Re: Application 2016/6670/T

Planning Application No 2016/56670T

Re: Structural Engineers Report 12. September 2013 (Andrew R Martin

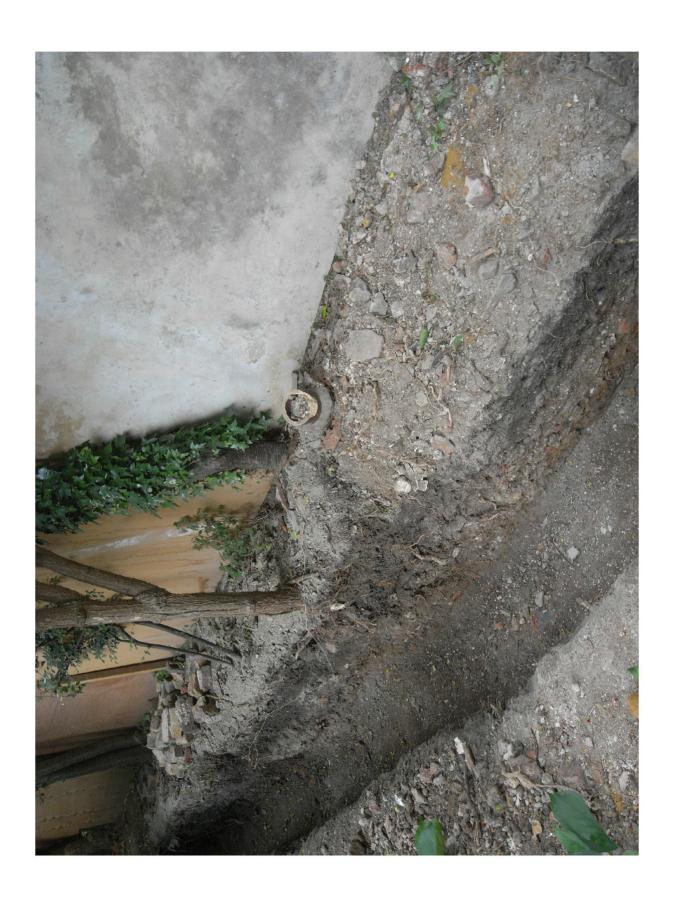
During the 2013 replacement of the original boundary wall between 22 and 20 Hilltop Rd, albeit with slightly less retained level, Genesis' surveyors had inaccurately alleged that the collapse had been caused "entirely" by roots from several adjacent trees in the garden of No 20. Evidence that this was complete nonsense can be seen in the attached photo of that wall's new foundation trench.

The wall between 20 and 22 had no foundation whatsoever.
